Re: Dowe's Quarry Expansion Project – Response to Tenterfield Shire Council

This letter provides a response to the request for clarification and additional information provided by Tenterfield Shire Council (Council) on 20 December 2019 regarding the proposed expansion and continued operation of the Dowe's Quarry (the Project). This response has been prepared by R. W. Corkery & Co Pty Limited (RWC) and will be incorporated into a larger response to the submissions Council received following public exhibition of the Environmental Impact Statement for the Project. This information has been extracted and provided separately in order to assist with Council's assessment of the application.

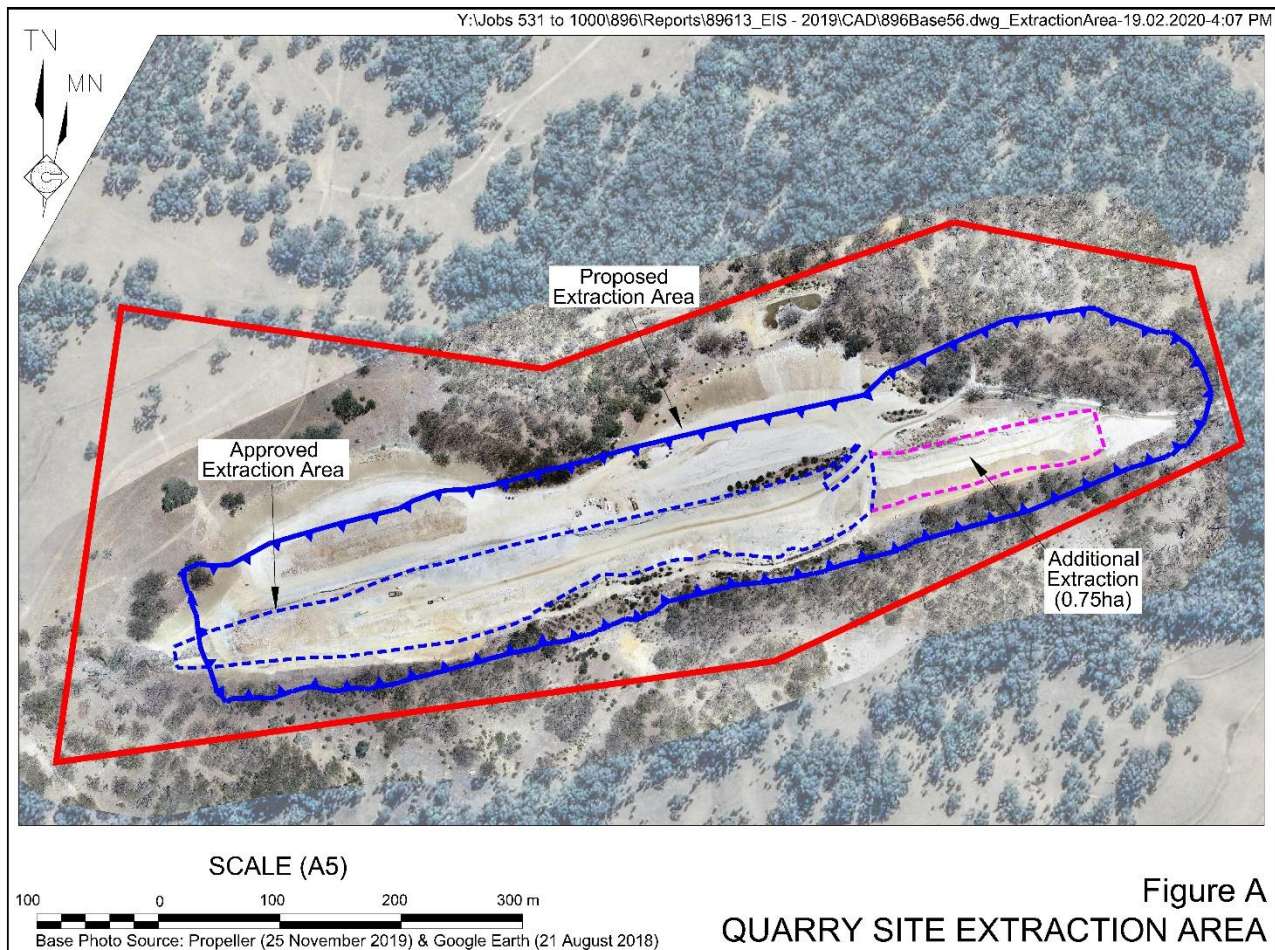
Identify where (on map) existing operations exceed approved (ref p1-8).

DMcC has acknowledged that extraction activities under the existing approval (DA 2014.078/1) have exceeded the boundary of the extraction area. **Figure A** presents the area of additional extraction that covers approximately 0.75ha.

As is evident from **Figure A**, the additional area that has been extracted has since been backfilled with fines and overburden. Should the current development application not proceed this area would be revegetated and rehabilitated.

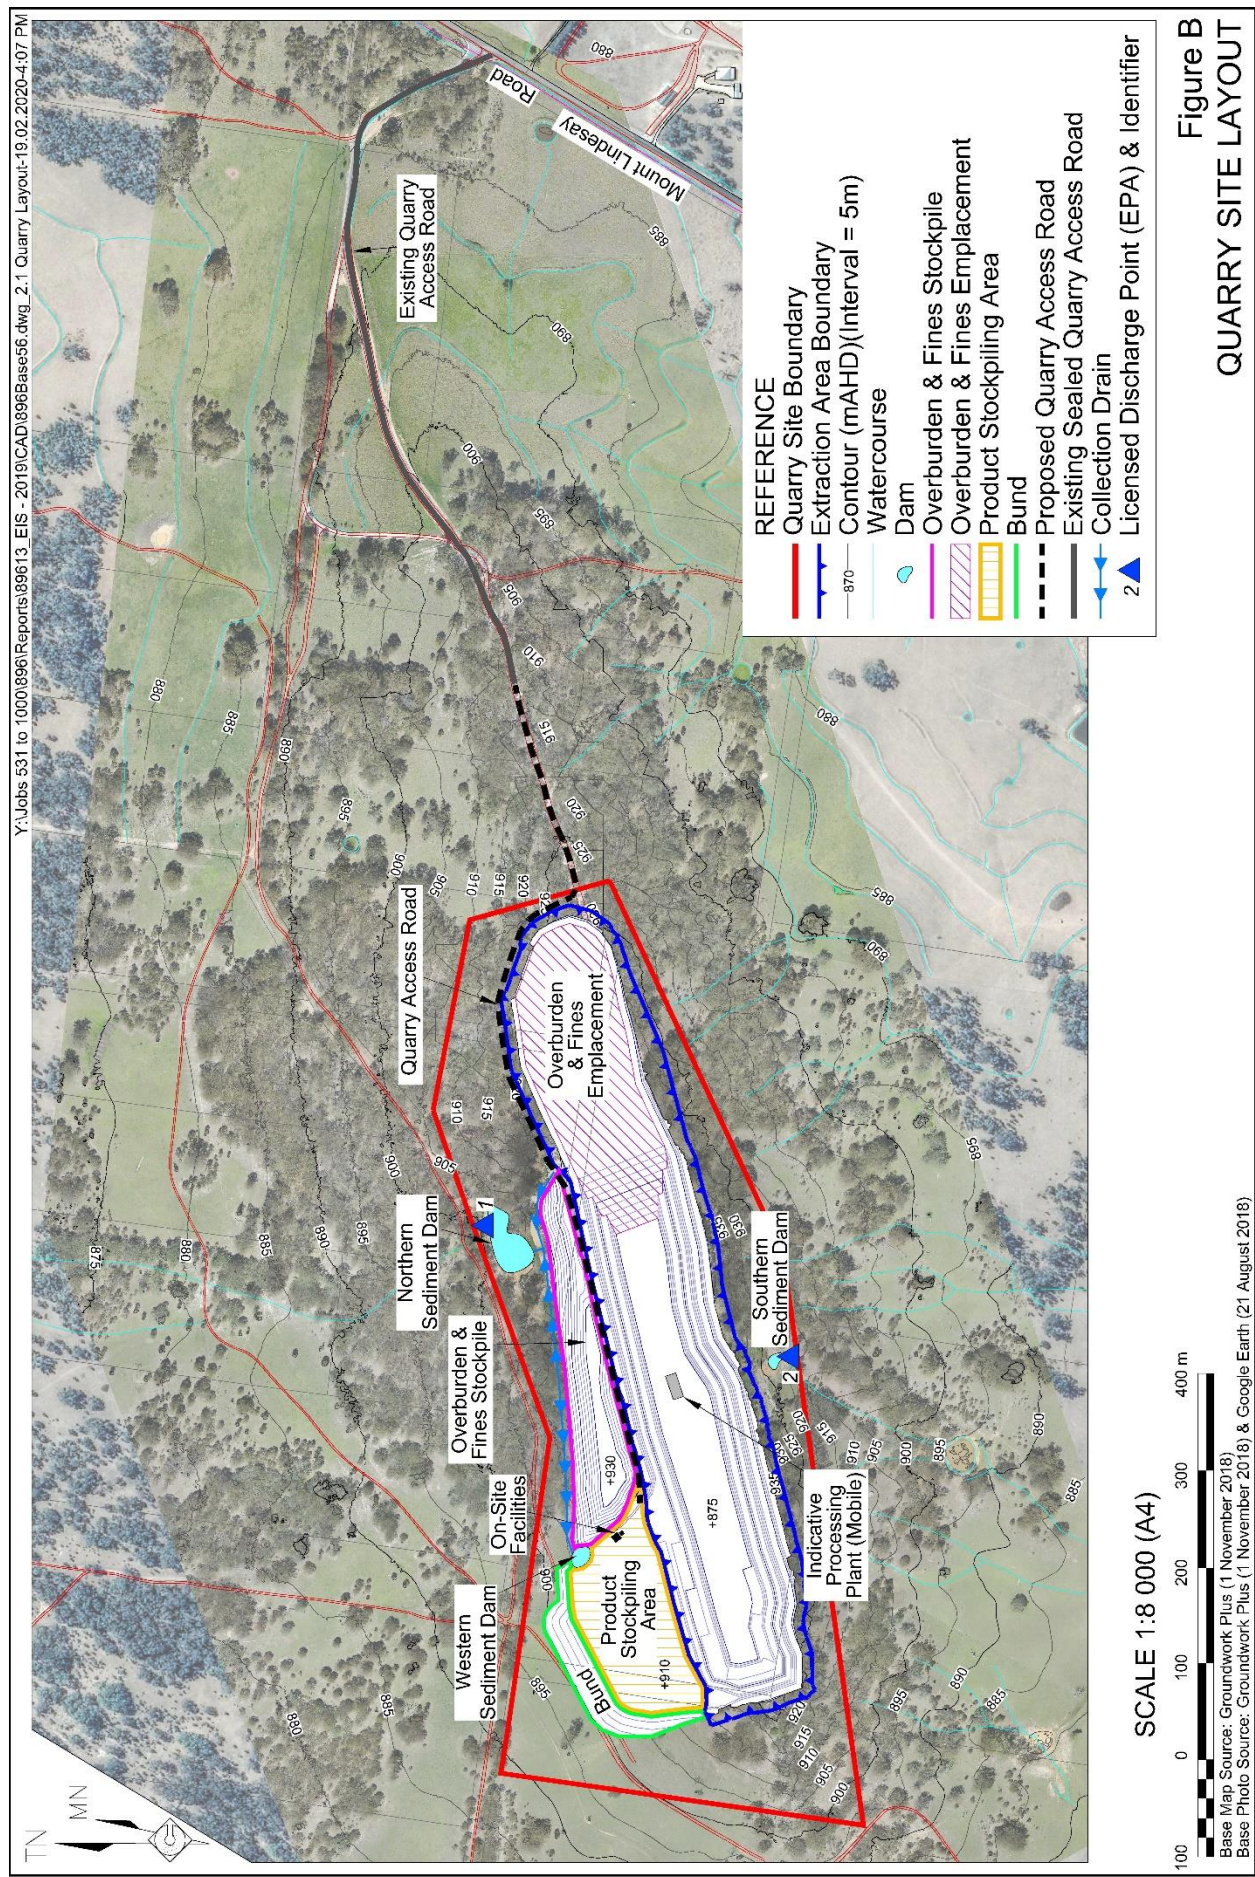
EIS indicates it [processing area and bund] at an elevated site within quarry – 910m AHD – during site inspection Terry Woods indicated that this location is to be changed to the quarry floor – EIS

and Figures need to be amended to reflect proposed change – noise and air quality assessments adjusted accordingly.

In response to the community feedback received on the Project, DMcC has investigated opportunities to minimise potential environmental impacts associated with the ongoing Quarry operation. This includes relocating processing activities to the Quarry floor. **Figure B** presents the updated layout of the Quarry with the mobile processing equipment located in the extraction area. It is predicted that the change in elevation to 905m AHD during Stage 1 and Stage 2 of operations and an elevation of 875m AHD during Stage 3 of operations would reduce the dust and noise levels experienced at the closest privately-owned residences.

The noise and air quality assessments have been updated to reflect this change with the outcomes of assessment predicting compliance with all relevant noise and air quality-related criteria. Figures presented in this document may be relied upon for any development consent and therefore the EIS will not be updated unless requested by Council following determination of the application.

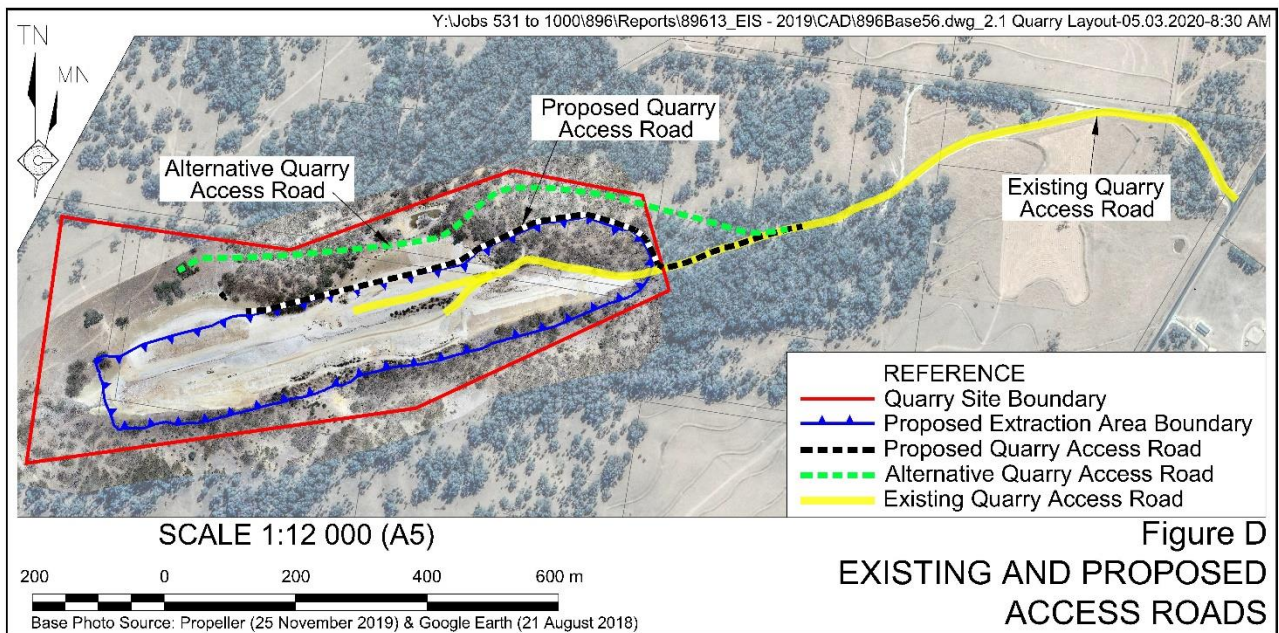
Processing area and bund as identified on Indicative Quarry Site plan - already constructed? Referenced as future works? Was any clearing undertaken in the areas as identified on Figure 2.8 to create this area?

Figure C presents the areas proposed for clearing superimposed on aerial photography dated 25 November 2019. This figure shows where a level area has been developed by on-site earthworks. It is acknowledged that the area has extended outside the boundary at the edges (it is estimated that this area covers approximately 2,000m²). DMcC has not cleared vegetation for the development of this area. The vegetation in this location was cleared by the landowner under separate permit. However, it is acknowledged that DMcC has pre-emptively undertaken works to level this area. This has not included extracting material for sale.

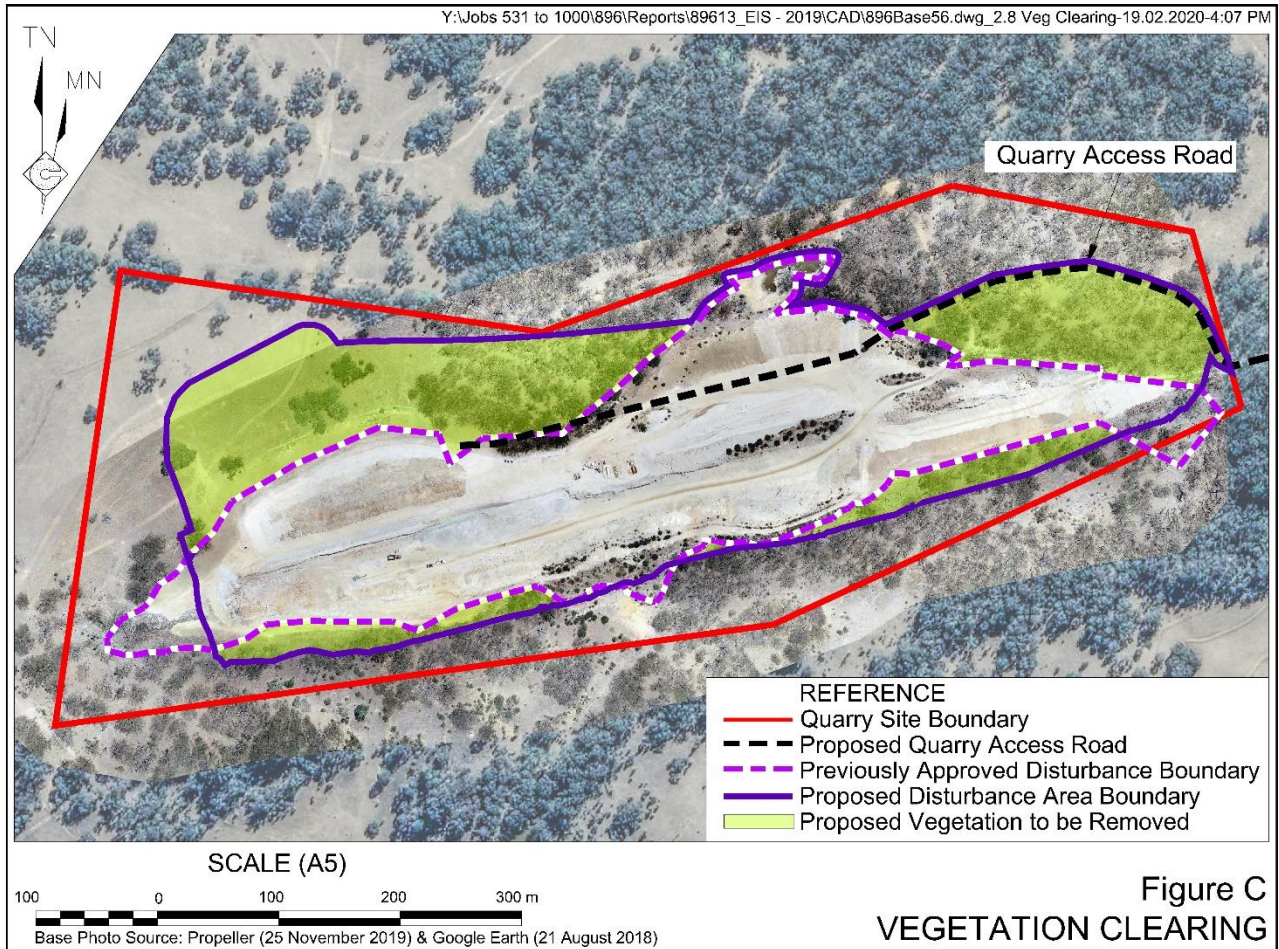
Various figures make reference to “proposed quarry access road” – clarification as to the existing road and proposed.

Figure D presents the alternative, existing and the proposed Quarry Access Road. The development application originally identified the alternative quarry access road following the northern edge of the Overburden and Fines Stockpile. However, the alternative quarry access road alignment was abandoned to avoid vegetation clearing impacts. As shown on **Figure D**, the Quarry will rely on the existing Quarry Access Road (which consists of approximately 785m of sealed road commencing

sealed road commencing from the intersection with the Mount Lindesay Highway) until it connects to the proposed quarry access road. The 785m sealed section of the existing quarry access road reduces dust generation for privately-owned properties to the east of the Quarry.
